HISTORIC AND DESIGN REVIEW COMMISSION

HDRC CASE NO: 2018-206
ADDRESS: 215 BARRERA
LEGAL DESCRIPTION: NCB 713 BLK 10 LOT SW 98.0 FT OF 4
ZONING: RM-4,HS
CITY COUNCIL DIST.: 1
DISTRICT: Lavaca Historic District
LANDMARK: Weingartz, Fritz - House
APPLICANT: Cynthia McBride Snell
OWNER: Cynthia McBride Snell
TYPE OF WORK: Front Yard Fencing
APPLICATION RECEIVED: April 30, 2018
60-DAY REVIEW: June 29, 2018
REQUEST:

The applicant is requesting a Certificate of Appropriateness for approval to install a new front yard fence featuring metal-frame cattle panel with a driveway gate.

RE: Fence Request
215 Barrera 78210

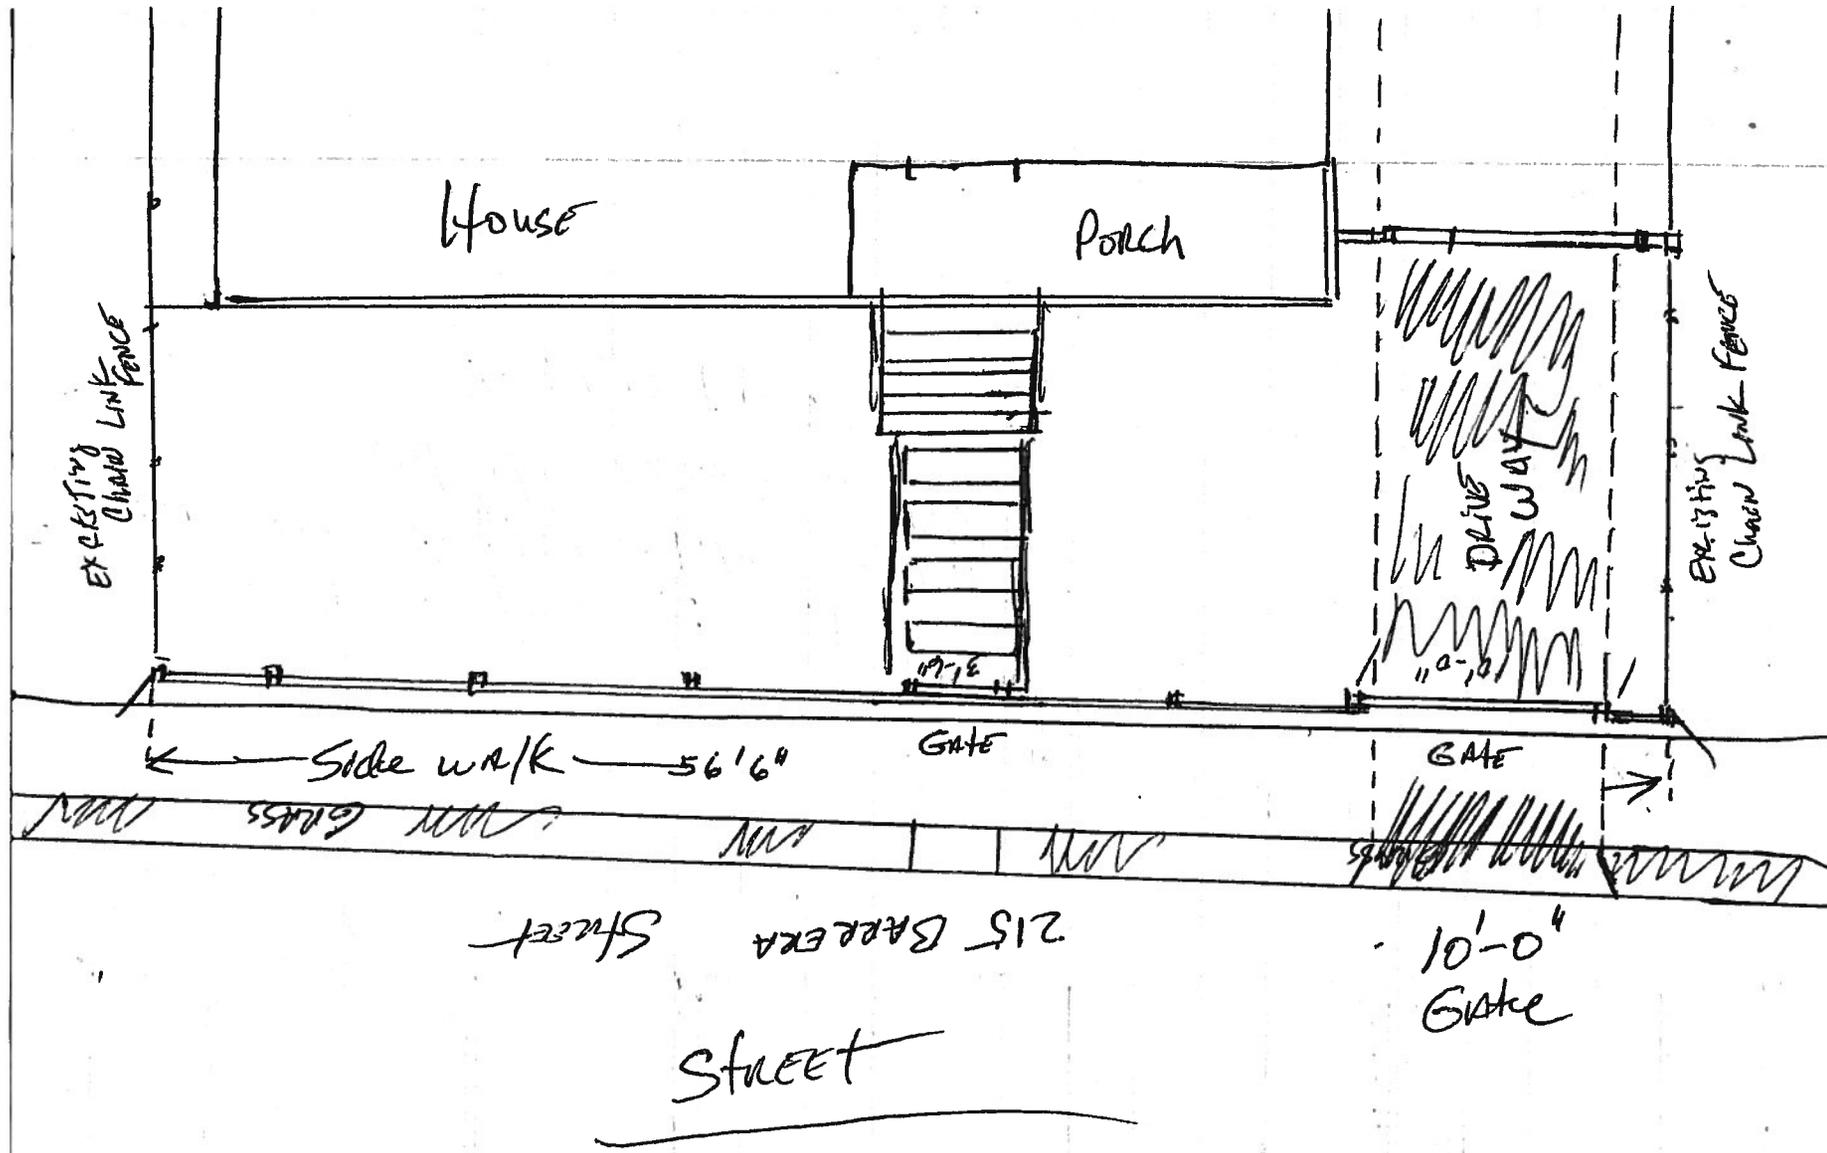
- b. FENCE LOCATION - The applicant has proposed to install a cattle panel fence to span the width of the property, including a gate spanning across the driveway. According to the Guidelines for Site Elements 2.B.ii, new front yard fences should not be introduced within historic districts that did not historically have them. While staff finds that a fence was not currently present on this property, fences are found on Barrera and within the Lavaca Historic District. According to the Guidelines for Site Elements 2.C.i., privacy fences should be set back from the front façade to reduce their visual prominence. Staff finds that the fence should turn at the driveway to meet the corner of the structure, rather than spanning across the driveway as proposed. Staff finds that the driveway gate, if included, should be set back behind the front façade plane of the structure.

- c. FENCE DESIGN - According to the Guidelines for Site Elements 2.B.i., the design of the fence should respond to the design and materials of the primary historic structure or structures of a similar style in the neighborhood in relation to scale, transparency, and character. Staff finds that the proposed metal-frame cattle panel picket fence is not appropriate for the Folk Victorian style of the home. Staff finds that a wood picket, wrought iron, or wood-framed cattle panel fence would be appropriate.

Staff recommends approval based on finding b and c with the following stipulations:

- i. The cattle panel fence should feature wood framing with metal wire.
- ii. The fence should turn at the driveway to meet at the corner of the structure, as opposed to spanning across the driveway in the front.
- iii. The driveway gate should be located behind the front façade plane of the structure or removed from the design.
- iv. That no portion of the fence exceed four feet in height.
